Planning Department

PLAN COMMISSION MEETING NOTICE AND AGENDA Thursday, October 20, 2022 6:00 PM

Date: August 16, 2022
To: LAKE PEWAUKEE SANITARY DISTRICT
From: Nick Fuchs, Planner & Community Development Director
RE: Staff Comments – Rezoning & Comprehensive Master Plan Amendment

Comprehensive Master Plan Exhibit "A"

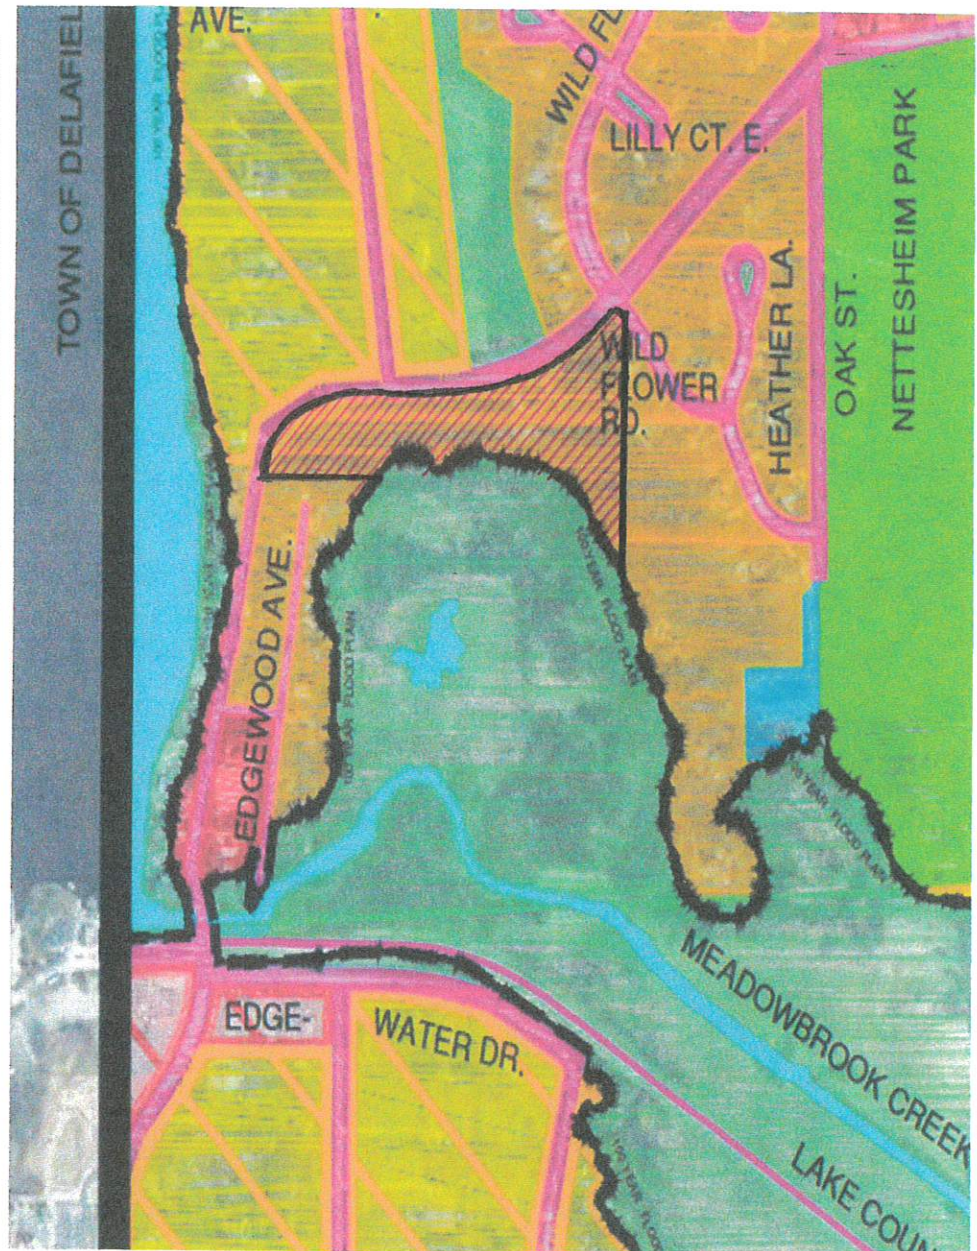
1. A Comprehensive Master Plan exhibit must be provided. This is similar to the exhibit that shows the location and change in zoning, but would request a change in future land use designation from Medium Density Residential to Government/Institutional. This would include the area in orange below.

1. Enclosed is a Comprehensive Master Plan Exhibit "A" which indicates the requested current Medium Density Residential to be changed to Government/Institutional. The area is outlined in black ink and hatched with red ink. To be clear and simple – the area that is orange, change to blue (everything outside the floodplain) per the Cities maps.
2. We will adhere to all the setbacks and consider all the comments regarding the site plan items a-f. Building materials will be discussed with the city (item g). There is 1 large pine tree and 1 large oak tree that the district would like to save and design around. The tree line should be preserved to screen from the neighbors and additional landscaping shall be added to enhance overall site appearance and screening.
3. All setbacks shall be met. A detailed site plan will be forthcoming with actual surveyed ROW and setbacks shown.

Request to change the current Medium Density Residential to Government/Institutional. The area requested is hatched in red.
